Keystone RV Company

SAFETY ADVISORY # 20-377

Cougar 24RDS Range Installation

Fig. 1

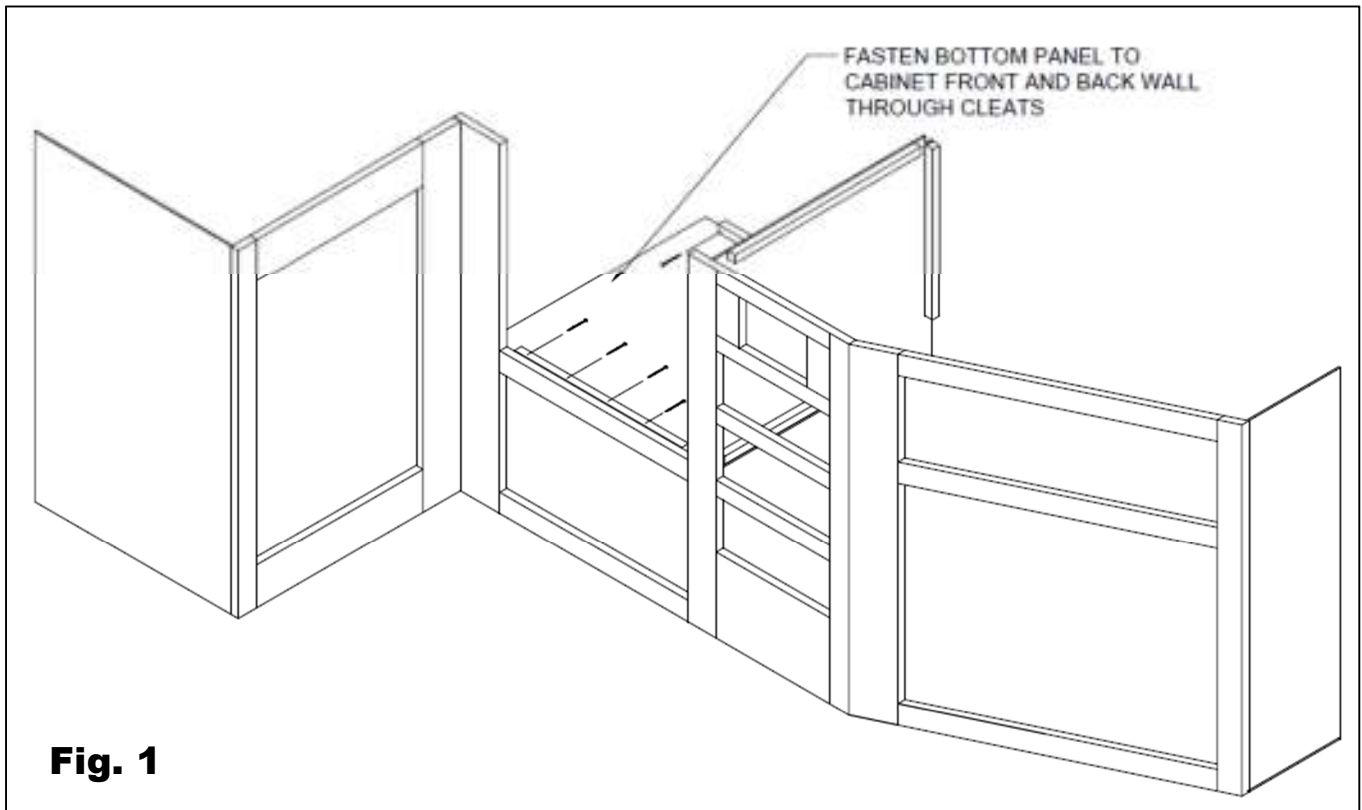
Keystone is conducting a voluntary RECALL notification campaign in accordance with the National Highway Transportation and Safety Act. It has been decided that the vehicles in the recall population have an interior range cooktop that the burner flame may be affected during furnace operation. Under certain conditions during furnace operation, the interior range cooktop burner flame can invert leading to an increased risk of personal injury, and/or fire.

The remedy is to remove the range cooktop and install divider panels to block the return air of the furnace from affecting the burner flames.

Install the bottom panel first and left side panel second using 1 ¼" screws as shown in Figure 1 and figure 2.
